IEEE 802.11
Wireless Access Method and Physical Layer Specifications

Title: **Extended Interframe Space (EIFS)**

Abstract: **This paper provides suggested text changes to P802.11/D3.1 to implement the “Smart IFS” proposal put forward by the Multirate Working Group to ameliorate the impact of unsupported data-rate transmissions on neighboring BSSs.**

Action: **Adopt the text changes proposed in this paper for inclusion in P802.11/D4.0.**

Figure 1, IFS Relationships

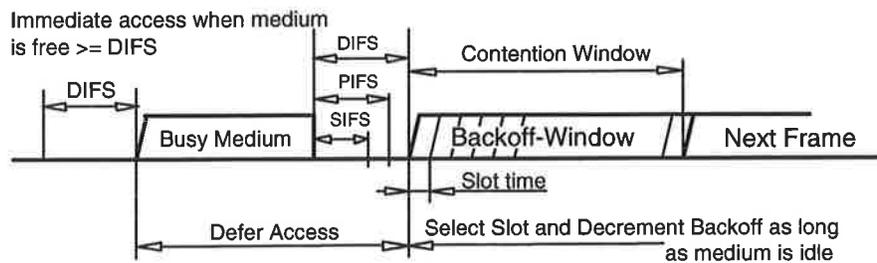
The time interval between frames is called the inter-frame space. A STA shall determine that the medium is free through the use of the carrier sense function for the interval specified. ~~Three~~Four different IFSs are defined so as to provide of priority levels for access to the wireless media. The following ~~three~~four different IFSs are defined:

- a) SIFS **Short Interframe Space**
- b) PIFS **Point Coordination Function (PCF) Interframe Space**
- c) DIFS **Distributed Coordination Function (DCF) Interframe Space**
- d) EIFS **Extended Interframe Space**

Figure 5, DCF Timing Relationships

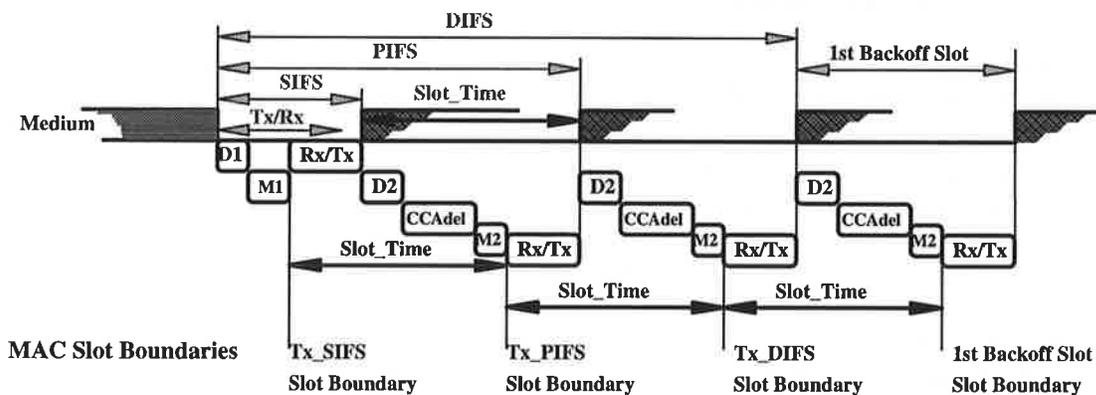
The EIFS is derived from the SIFS and the DIFS and the length of time it takes to transmit an Acknowledge control frame at 1 Mbps by the following equation:

$$\text{EIFS} = \text{aSIFS_Time} + \text{aACK_Time} + \text{aDIFS_Time}$$
